Access Compliance Report

Public Rights-of-Way

Intersection ID: 10033946	Main Street: PARK_RD	Cross Street: N/A	Location: SW
ADA ID: 008DFAF25E48	Ramp Type: Perp	Initial Pass/Fail: Fail	Overall Compliance: No
		Severity Score: 12.5

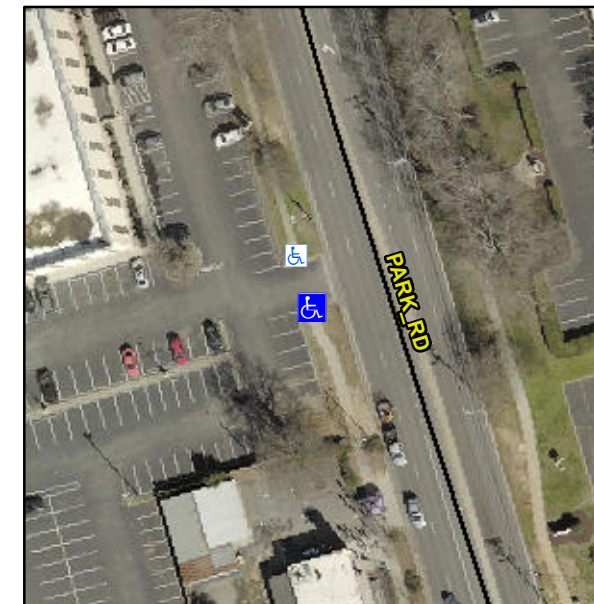
Not Found, R304.2.2

Compliance	Description	Data	Compliance	Description	Data
N/A	Ramp Length (in)	109.0	No	Ramp Slope (%)	8.9
Yes	Ramp Width (in)	71.0	Yes	Ramp XSlope (%)	0.1
N/A	Flare Type LT	N/A	N/A	Flare Type RT	N/A
N/A	Flare Slope LT (%)	N/A	N/A	Flare Slope RT (%)	N/A
N/A	Flare Traversable LT?	N/A	N/A	Flare Traversable RT?	N/A
N/A	Landing Length (in)	N/A	N/A	DWS Provided?	N/A
N/A	Landing Width (in)	N/A	N/A	DWS Contrast?	N/A
N/A	Landing Slope (%)	N/A	N/A	DWS Length (in)	N/A
N/A	Landing X Slope (%)	N/A	N/A	DWS Full Width?	N/A
N/A	Landing Curb? (Y/N)	N/A	N/A	DWS Offset (in)	N/A
N/A	Shared Landing?	N/A			
N/A	Gutter Ponding?	N/A	N/A	Gutter Slope (%)	N/A
N/A	Gutter Lip Ht (in)	N/A	N/A	Gutter X Slope (%)	N/A
N/A	Painted X Walk1?	No	N/A	Painted X Walk2?	N/A
	X Walk 1 Direction	To N		X Walk 2 Direction	N/A
N/A	X Walk 1 Width (in)	N/A	N/A	X Walk 2 Width (in)	N/A
	X Walk 1 Slope (%)	1.0		X Walk 2 Slope (%)	N/A
	X Walk 1 X Slope (%)	0.3		X Walk 2 X Slope (%)	N/A

Remove & Replace Entire Ramp.
